Z-45  
(2017)

**BURNT HICKORY**  
Cobb, Georgia  
Tishon Norman  
01-11-2017  
SITE PLAN

**PETITION NO.:** Z-45  
**HEARING DATE (PC):** 08-01-17  
**HEARING DATE (BOC):** 08-15-17  
**PRESENT ZONING:** R-30, R-20

**PROPOSED ZONING:** RSL (Non-Supportive)  
**PROPOSED USE:** Non-Supportive Residential Senior Living

**Z1.00**

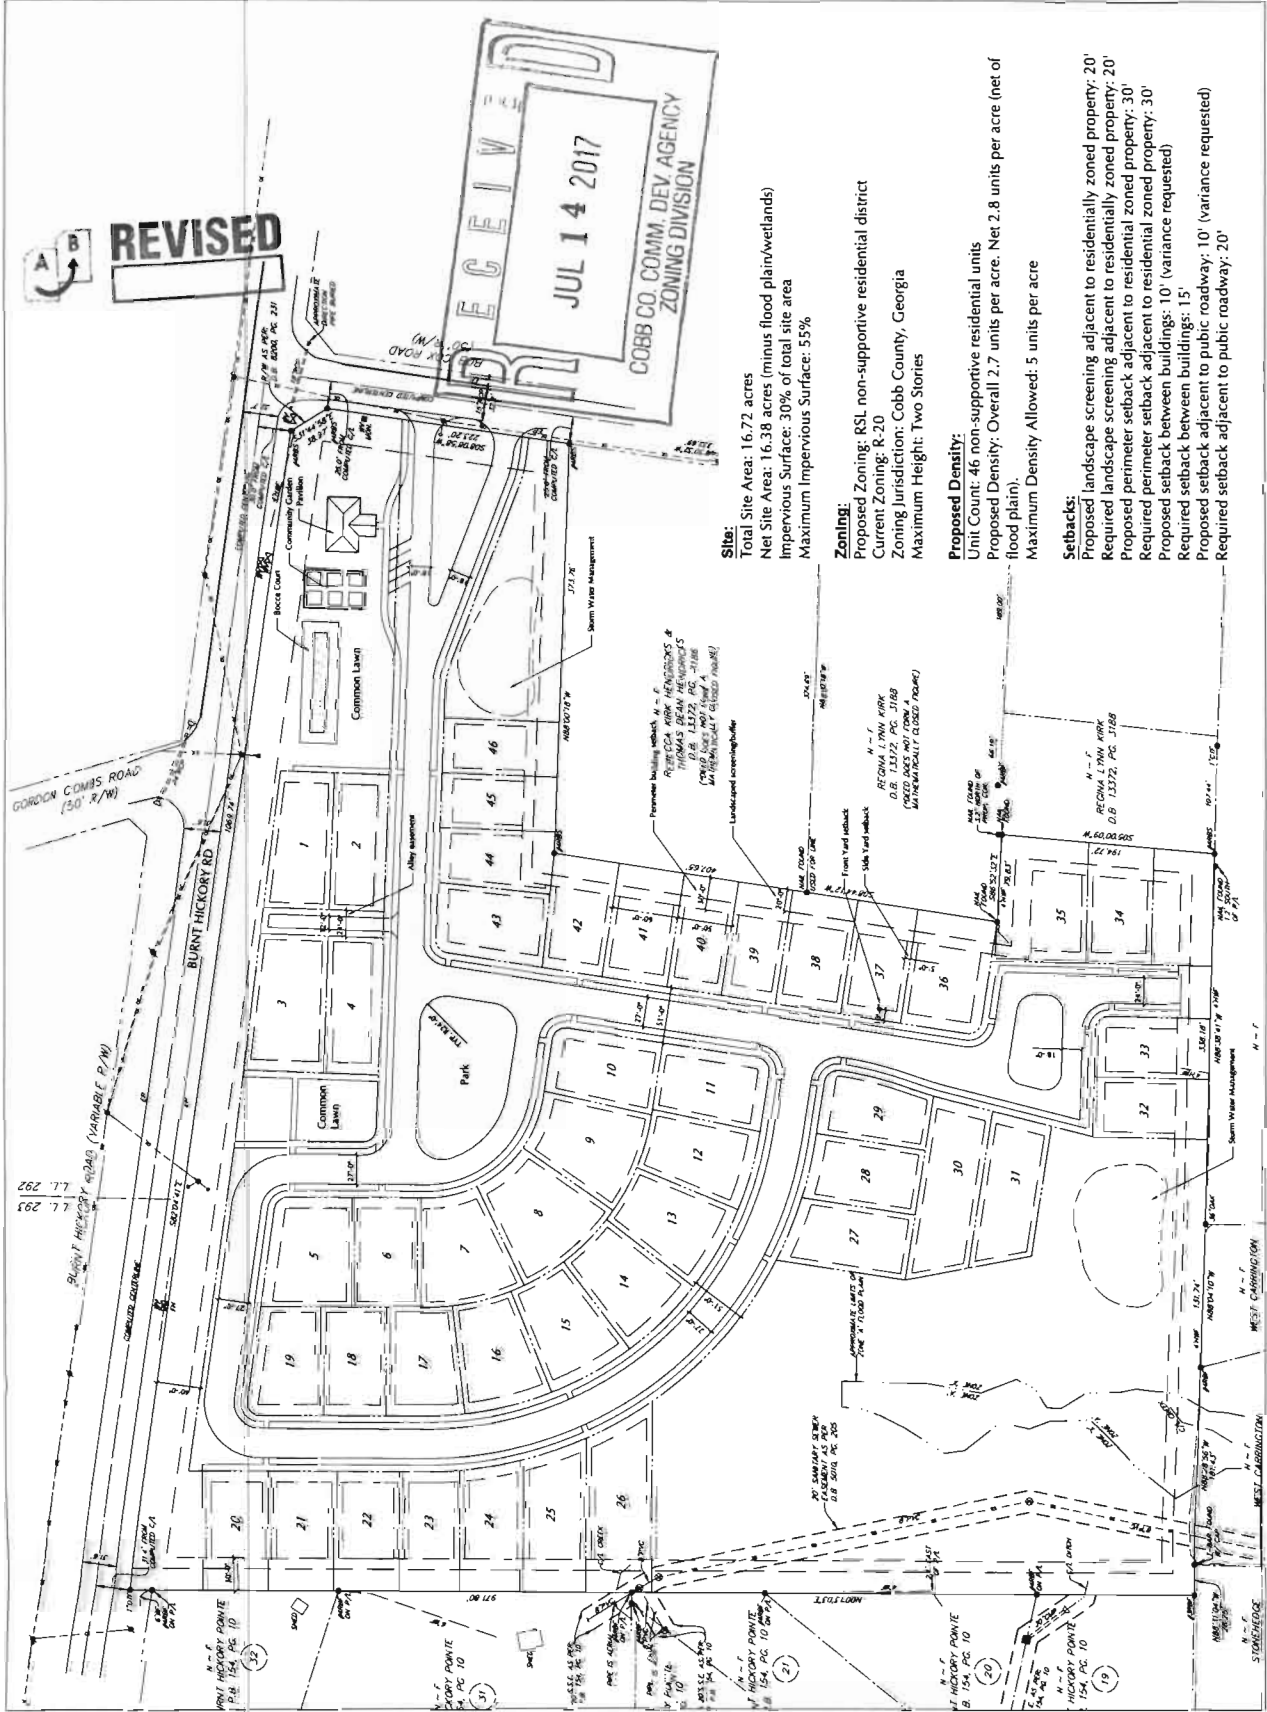
1. Reduction in the minimum setback between buildings from 15 feet to 10 feet;
2. Reduction in the minimum setback adjacent to public roadways from 20 feet to 10 feet; and
3. Reduction in the minimum perimeter building setback from 30 feet to 24 feet at one specific location as indicated on the site plan.

- Provide comprehensive hydrology/stormwater controls to include development of out parcels.
- Submit all proposed site improvements to Plan Review.
- Any **spring activity** uncovered must be addressed by a qualified geotechnical engineer (PE).
- Structural fill \_\_\_\_\_ must be placed under the direction of a qualified registered Georgia geotechnical engineer (PE).
- Existing facility.
- Project must comply with the Water Quality requirements of the CWA-NPDES-NPS Permit and County Water Quality Ordinance.
- Water Quality/Quantity contributions of the existing lake/pond on site must be continued as baseline conditions into proposed project.
- Calculate and provide % impervious of project site.
- Revisit design; reduce pavement area to reduce runoff and pollution.

3. Stormwater management for the site is proposed to be underground. Private roads and underground stormwater management will require that all stormwater infrastructure be maintained by the required homeowner’s association.

Recommend relocating entrance on Burnt Hickory Road further west to allow construction of a full length left turn lane at the entrance. Recommend access on Burnt Hickory Road include a deceleration lane and left turn lane. Recommend location and design be determined during plan review, subject to Cobb County DOT approval.

Recommend access on Bob Cox Road include a deceleration lane and left turn lane. If a left turn lane cannot be added due to geometric restrictions, recommend access be restricted to right-in/ right-out. Recommend location and design be determined during plan review, subject to Cobb County DOT approval.

Recommend the proposed gate be a minimum of 50' from the right-of-way and meet Cobb County Development Standards.

1. Maximum density of 2.5 units per acre net of any floodplain/wetlands;
2. Final site plan to be approved by the District Commissioner;
3. Landscape plan to be approved by the District Commissioner;
4. Fire Department comments and recommendations;
5. Sewer and Water Division comments and recommendations;
6. Stormwater Management Division comments and recommendations;
7. Department of Transportation comments and recommendations; and
8. Owner/developer to enter into a Development Agreement pursuant to O.C.G.A. §36-71-13 for dedication of system improvements to mitigate traffic concerns.
